ADDENDUM 001

JANUARY 28, 2013

**REQUEST FOR BID: 8TH & MAIN FARMER'S MARKET
CITY OF GRANDVIEW, MO PN: P-1101(19)
MODOT PN: STP-3322(406)
BID DATE: FEBRUARY 7, 2013, 2:00 PM**

8th & Main Farmers' Market
City of Grandview Missouri
Federal Aid Project No. STP-3322(406)
Addendum to Sheet C-007
Typical Pavement Sections

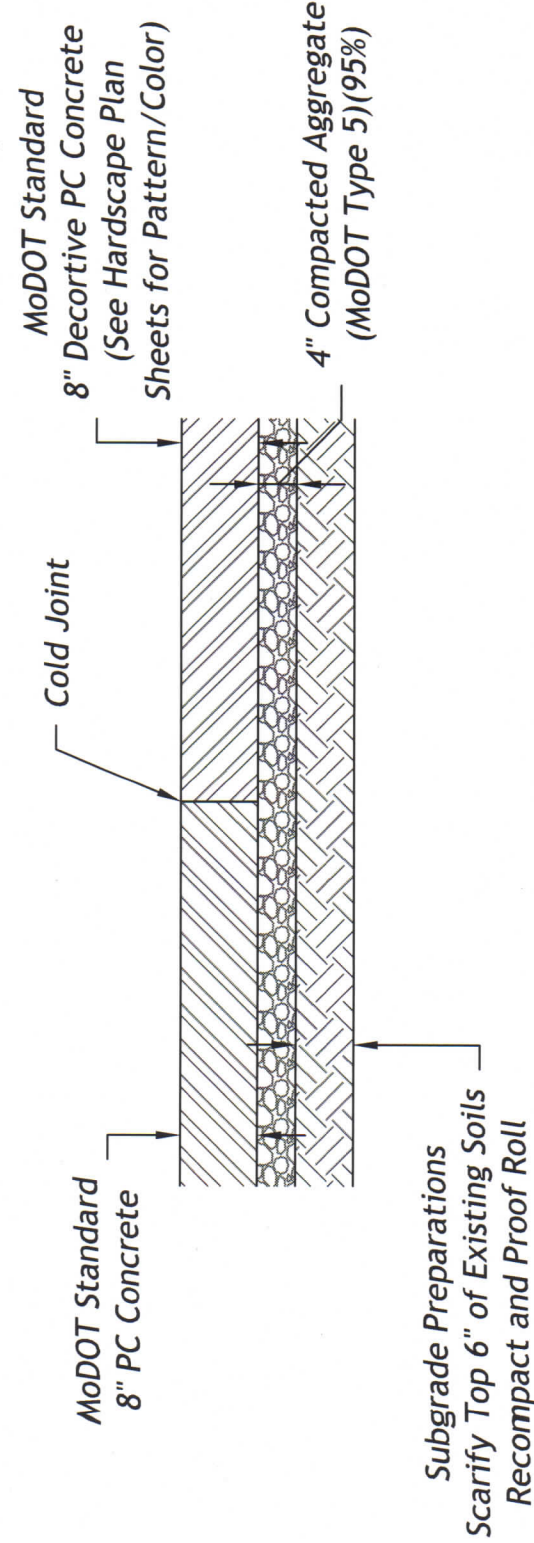
- Sheet C-002: General Note 11 contains a typo and should read: ALL **TREES** OUTSIDE THE GRADING LIMITS ARE TO REMAIN UNDISTURBED.
- Sheet C-007: Delete Note 2 in the top left corner of the sheet and replace with: At the City's direction, unsuitable subgrade under pavement shall be over excavated up to 24" and replaced with compacted aggregate (MoDOT Type 5) (95%). Any such over excavation and replacement shall be paid under **SUBGRADE STABILIZATION** bid item.
- Sheet C-007: See Cut/Fill Detail. The attached detail entitled "Typical Pavement Section" replaces Detail 2 shown on Sheet C-007. The detail was modified to show Subgrade Preparation requirements. Also see note JSP D.6 - Portland Cement Concrete Pavement and Subgrade Preparation.
- Sheet LF-300, Detail 2 Custom S.S. Weir Box. Weir shall be constructed from 304 stainless steel, 18 gauge with a brush finish.
